ADDENDUM #01

RFB – 163447 CNHS Security Fence Project

04.28.2025

VINYL CHAIN LINK FENCE

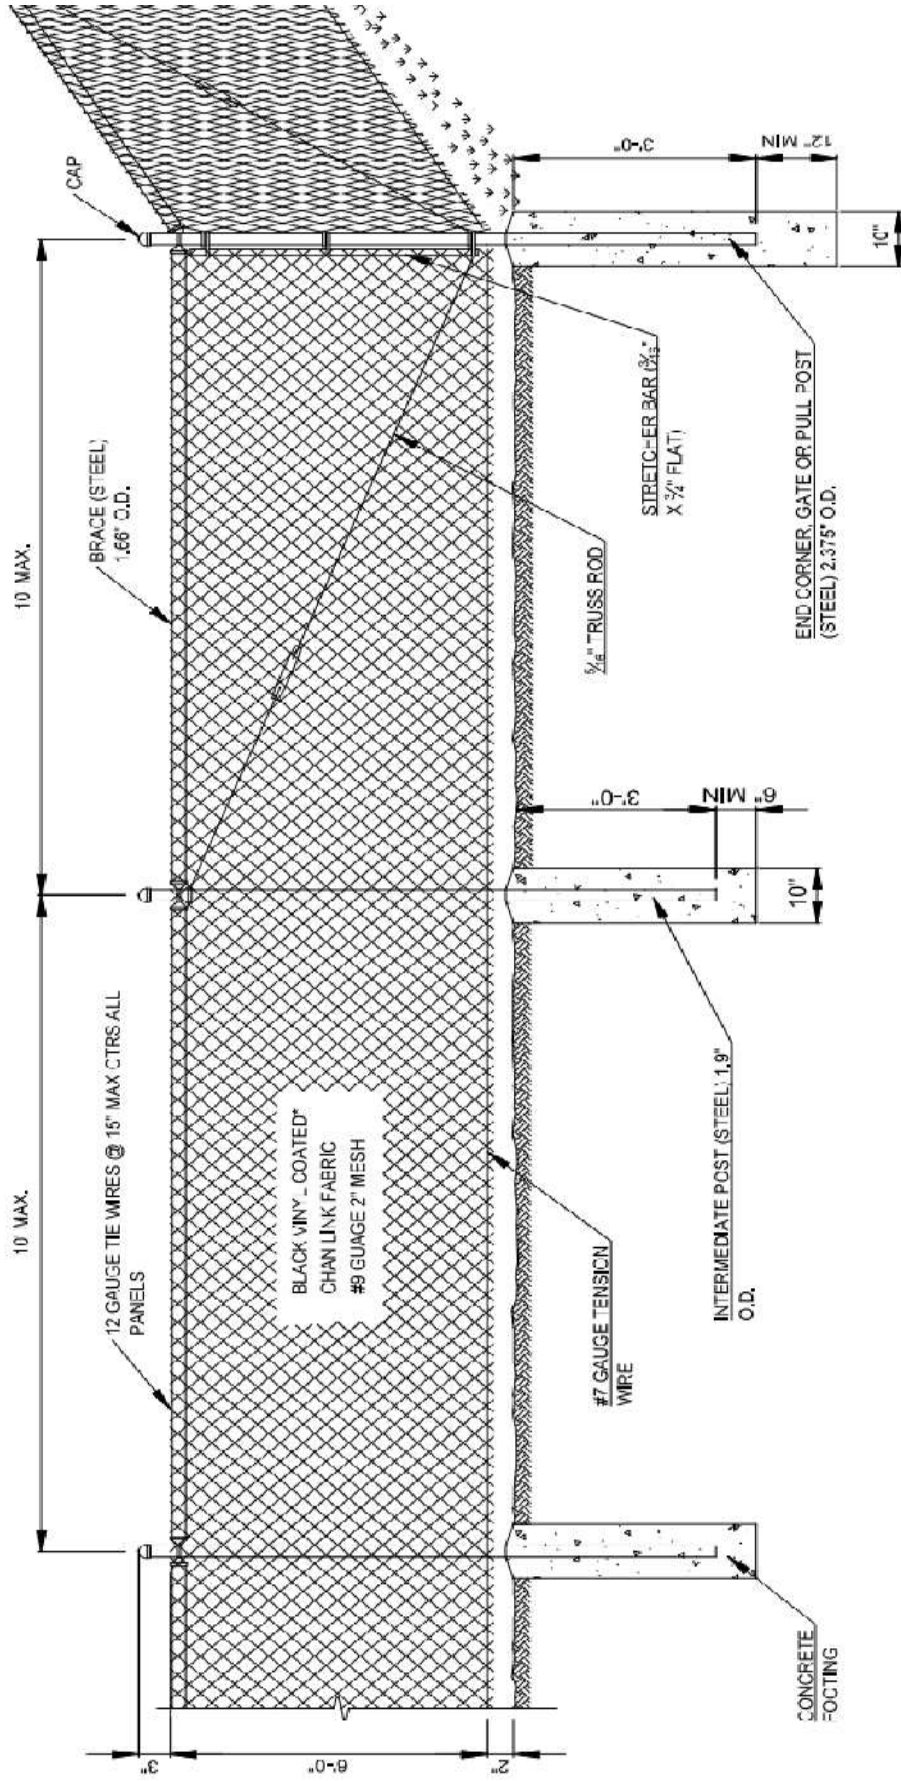
4. The wire is calling for 9g in the bid, generally for coated wire it is at least 8g. Can this be adjusted for bidding purposes?

5. Will the posts be set into the ground or concrete at the Redbird location in Sallisaw? And please verify for the location of Vinita as well.

Yes. All bidders to include 8 gauge coated wire.

All posts to be set in concrete per the detail provided in bid documents. Vinita site to match.
